MERCURY MerCruiser

Service Bulletin

☐ Warranty Information ☐ Service Information Bulletin No. 2003-10r1
☑ Parts Information

Hairpin Cotter 18-859746 is NLA

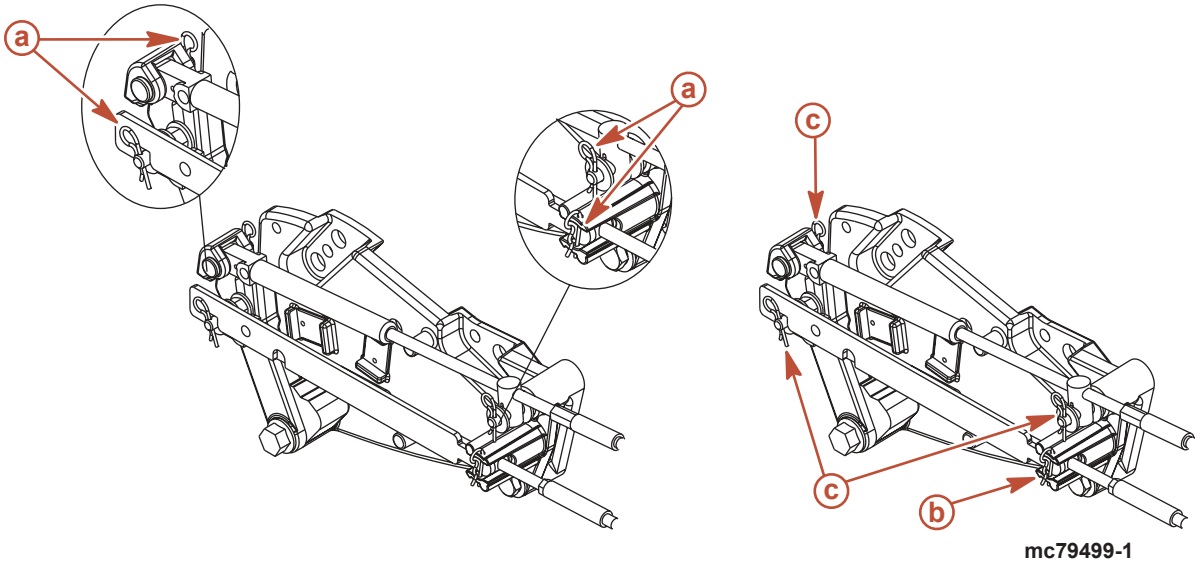
Hairpin cotter 18-859746 that retains the shift cables on the shift plate assembly on all MCM engines must be replaced with (1) of 18-32857-1 cotter pin at the shift cable anchor on the Alpha switch actuating arm and Bravo shift cable retainer plus (3) of 18-21071-1 cotter pins for the two studs and the clevis pin on the shift lever of both the Alpha and Bravo shift plate assemblies.

Qty. 1 of 18-32857-1 cotter pin for transom shift cable retention.

Qty. 3 of 18-21071-1 cotter pins for shift lever clevis pin and studs.

Bravo shift plate

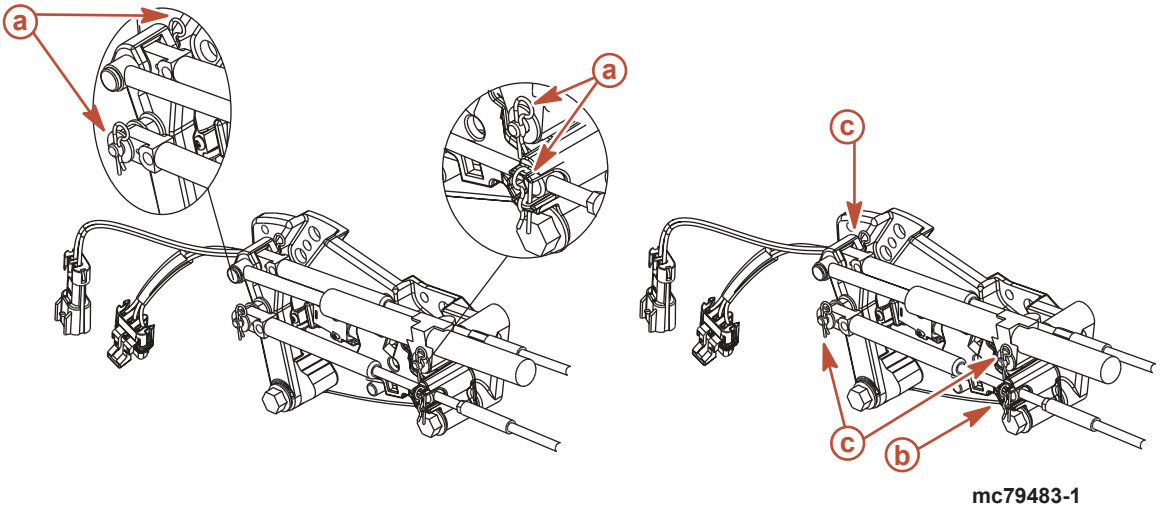
a - Hairpin cotters
b - Location to install 18-32857-1 cotter pin
c - Locations to install 18-21071-1 cotter pins
